**2018 GROUP A PROPOSED
CHANGES TO THE I-CODES
COLUMBUS COMMITTEE ACTION
HEARINGS**

April 15–23, 2018
Columbus Convention Center
Columbus, Ohio

2018 GROUP A – PROPOSED CHANGES TO THE INTERNATIONAL BUILDING CODE – GENERAL

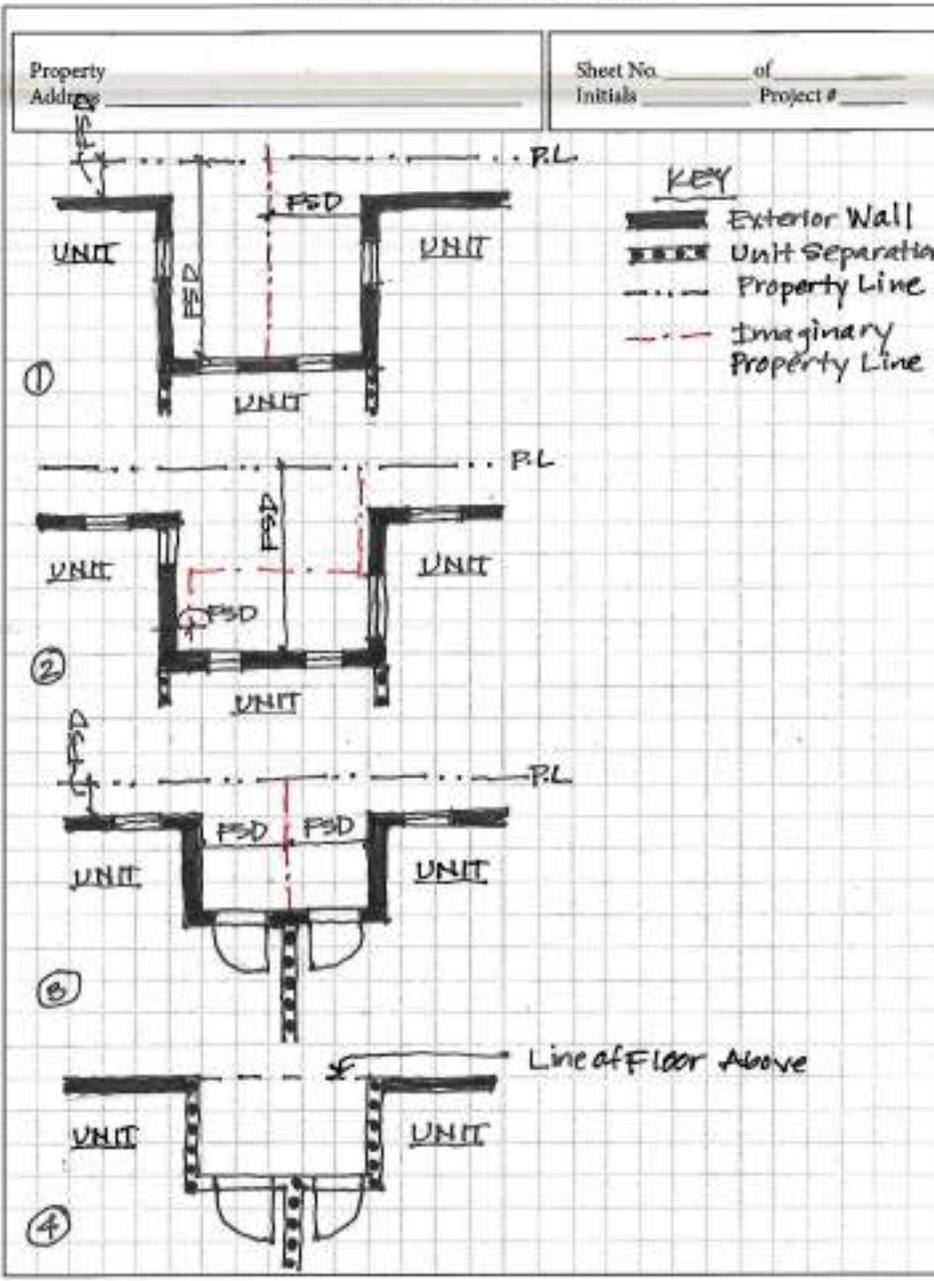
The code requires fire-rated construction between dwelling units, but does not specifically address the situation where the separating wall is exterior. The provisions of 705.3 establish a means to determine the required fire rating and allowable openings for exterior walls of two buildings on the same lot. The same principles should be applied to the requirements for dwelling unit separation.

Dwelling unit separation is intended to prevent a fire in one unit from spreading to other units in a building. If adjacent units have unprotected openings in close proximity, fire can more readily spread between units, and to exterior balconies, cladding and roof.

With increasing demand for greater density housing, architects are designing more multifamily residential buildings with smaller units, often with windows on opposite sides of courts.

3114.8.5.3(1)
Bracing Unit Distribution--Maximum Linear Length

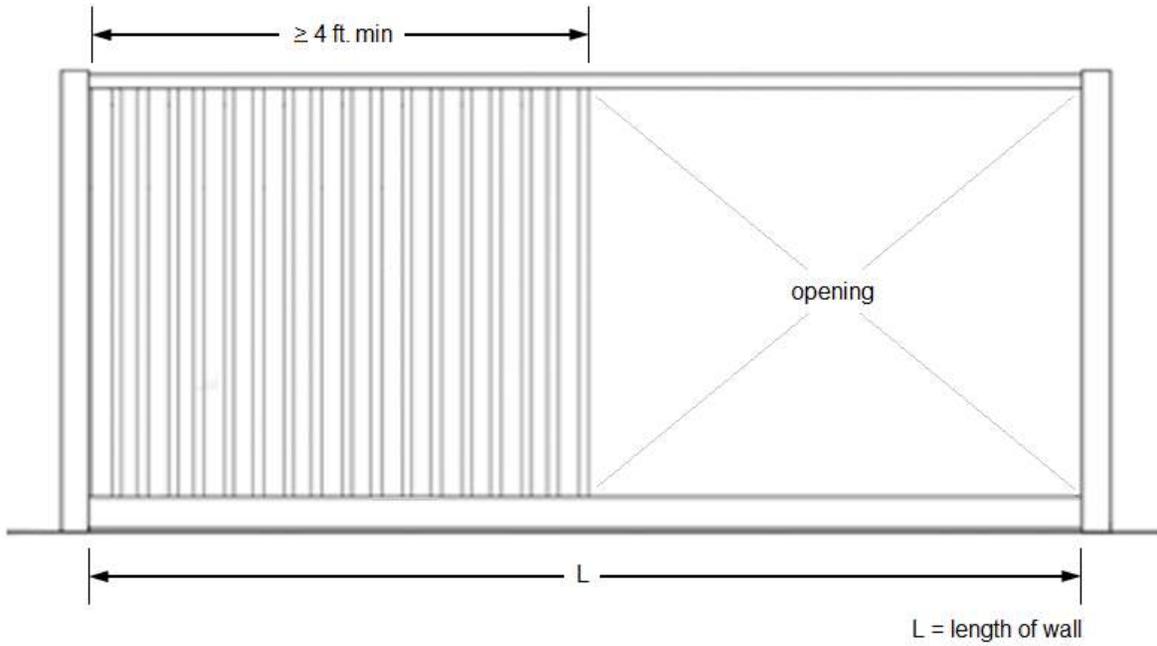
1. The total linear length of all openings in any individual side walls or end walls shall be limited to not more than 50% of the length of that side walls or end walls, as shown in Figure 3114.8.5.3(1).

3114.8.5.3(2)
Bracing Unit Distribution -- Minimum Linear Length

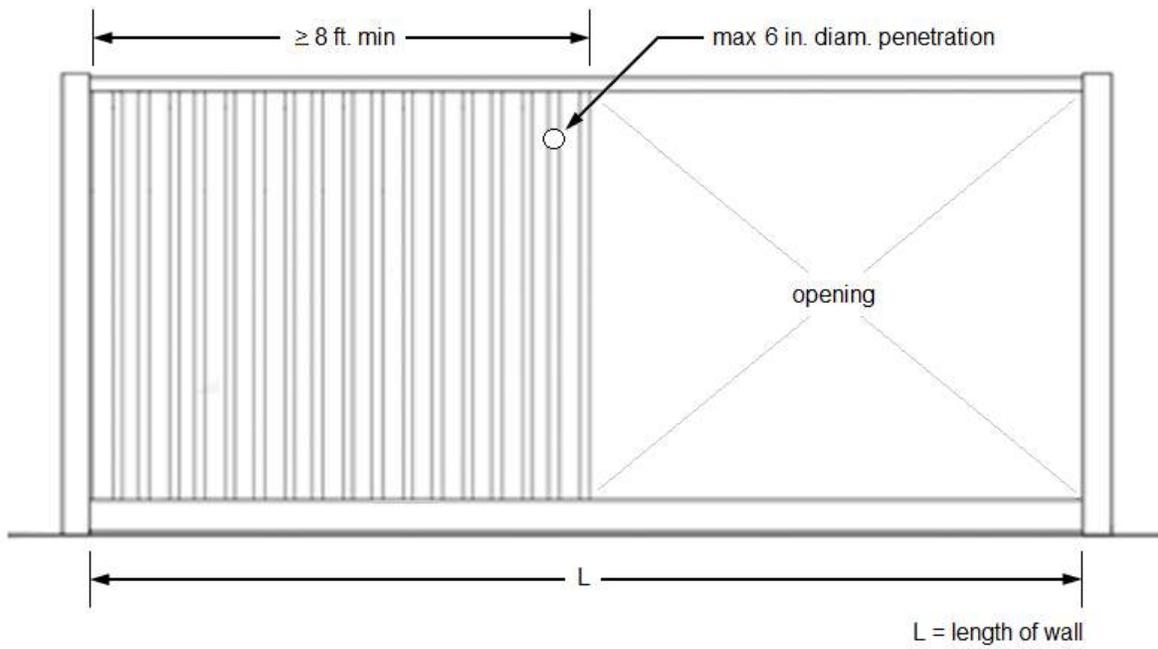
2. Any full height wall length, or portion thereof, less than 4 feet (305 mm) long shall not be considered as a portion of the lateral force-resisting system, as shown in Figure 3114.8.5.3(2).
